# Noncompliant Weld Inspection Techniques

## Line 114 Non Destructive Examination Final Report

Issue Date December 5, 2013

Weld 781 cited for indications of internal undercut from 44-49

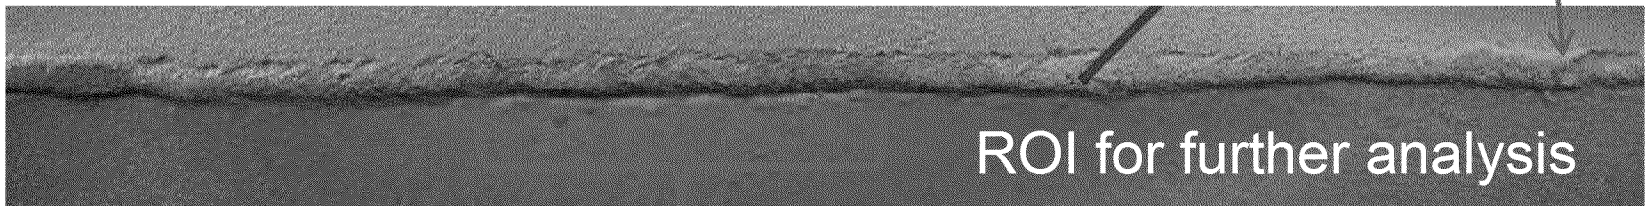
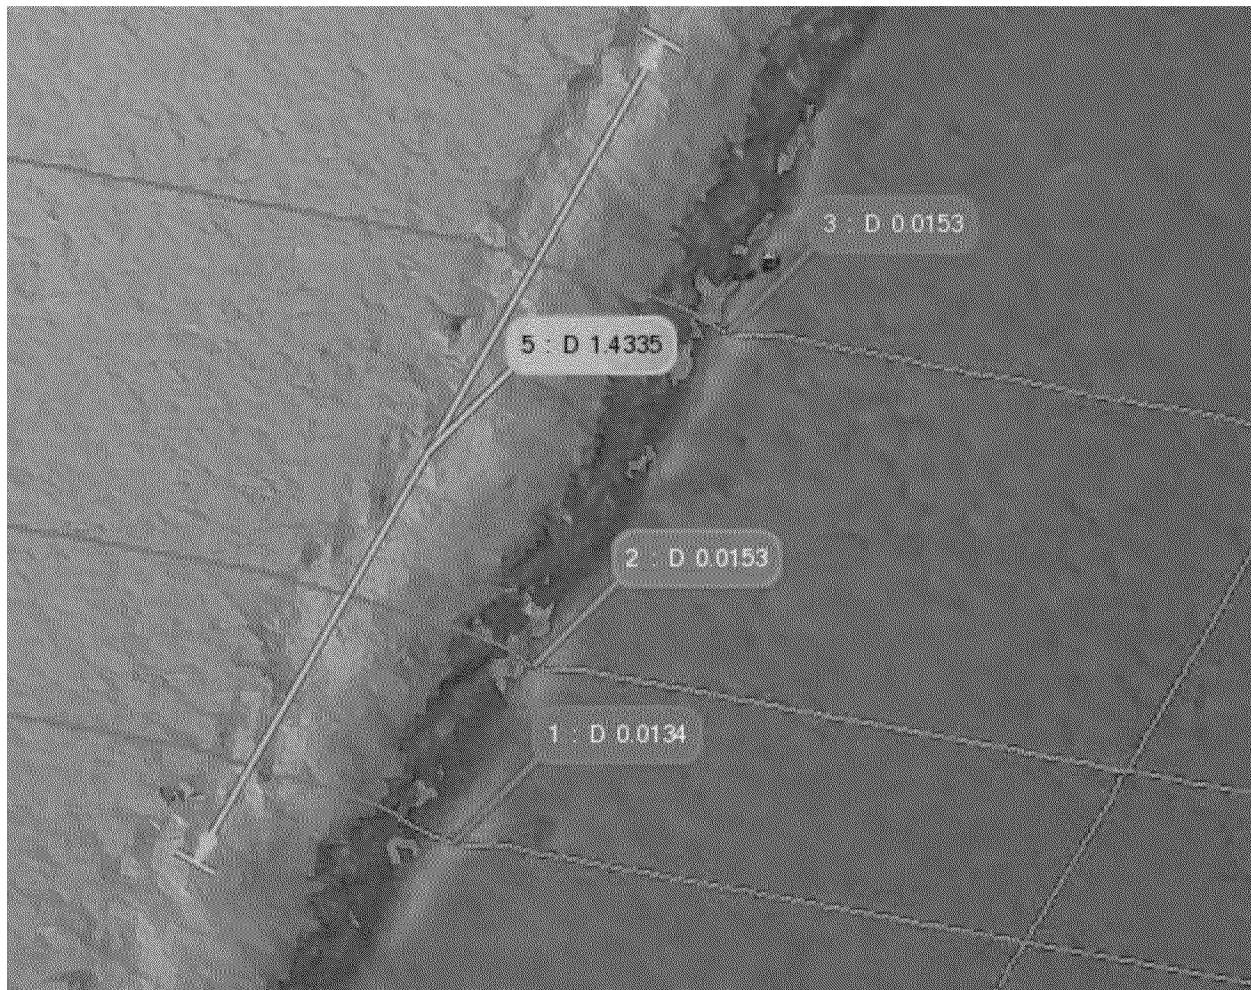
Confirms indications are mostly diffraction effects on minor hi/lo condition with 0 UC

Largest region is 1.5 long x up to 0.015 inches deep

Weld is acceptable per API 1104

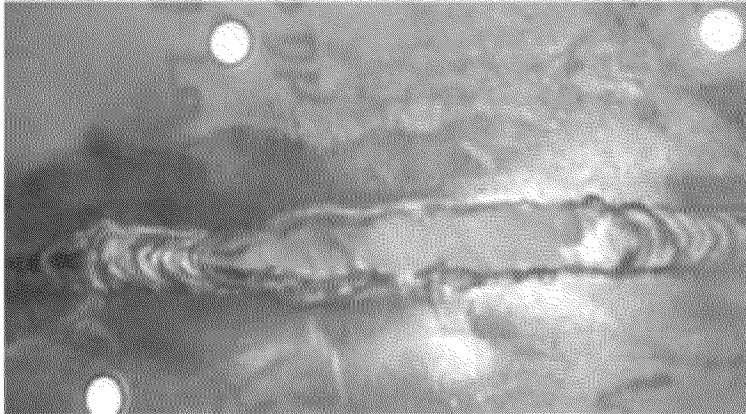
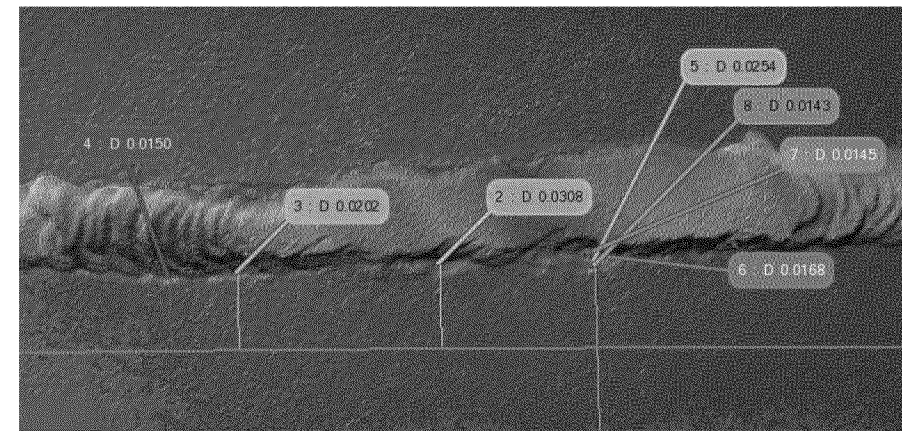
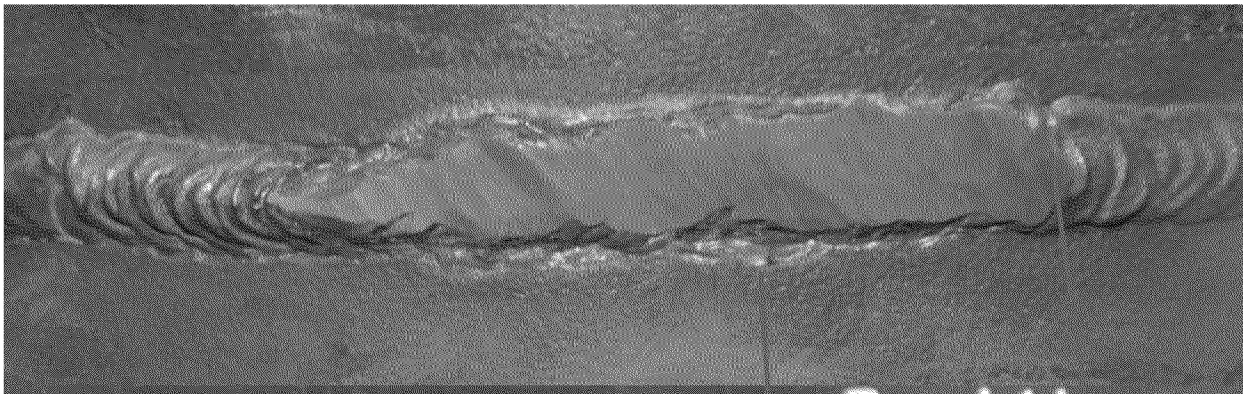
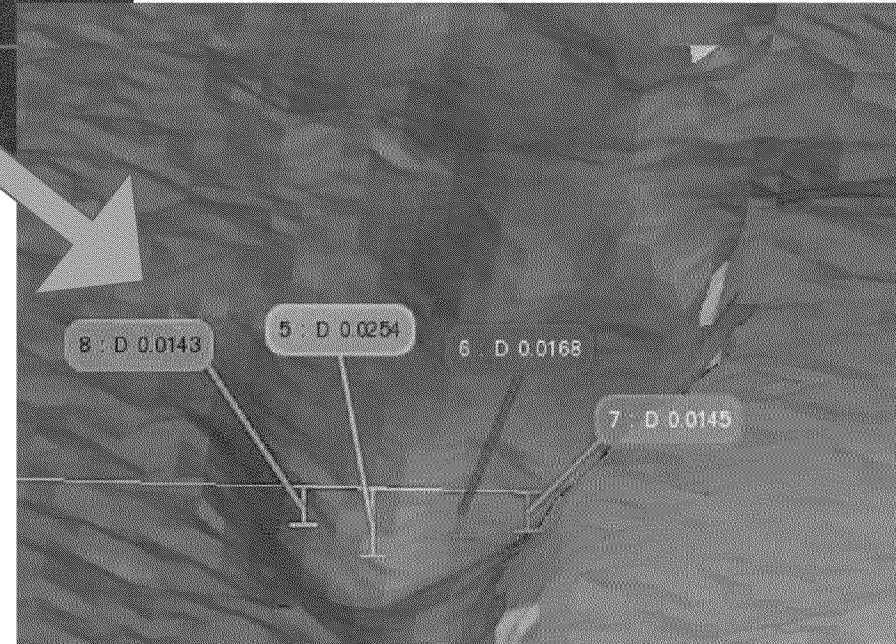
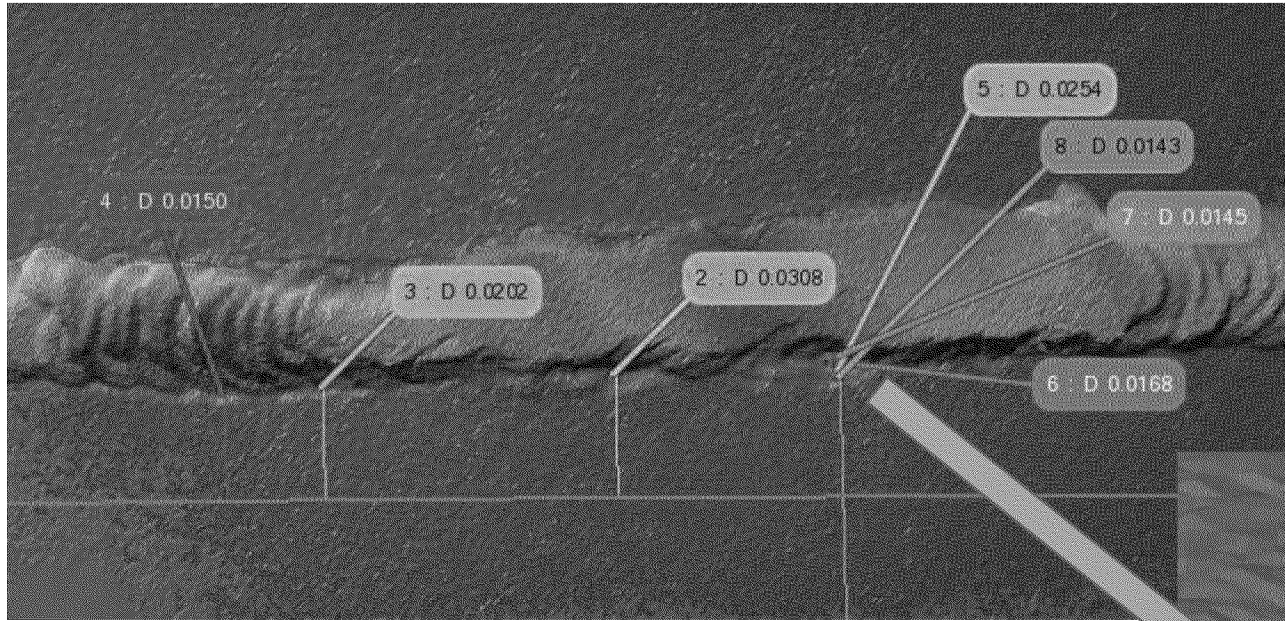
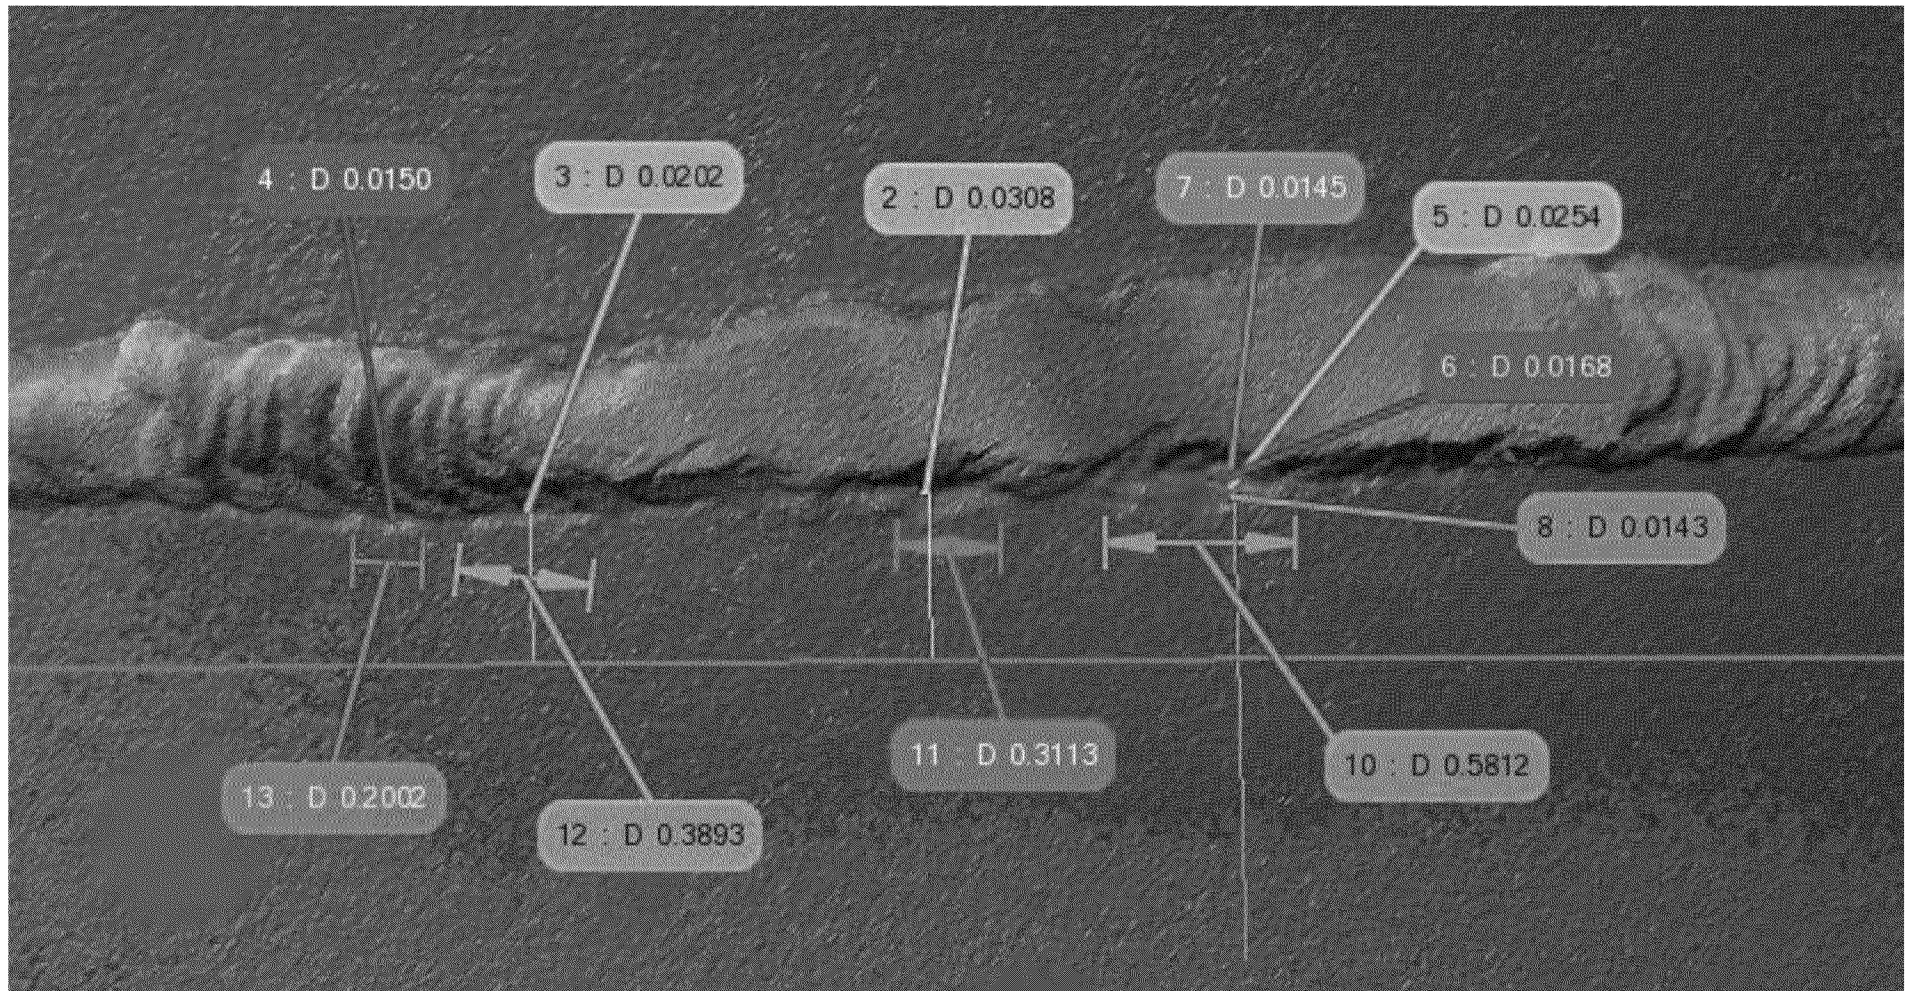
RT estimated depths of up to 0.030 inches

External undercut identified up to 0.030" deep

Sum of UC lengths < 1.5"

Weld is acceptable per API 1104
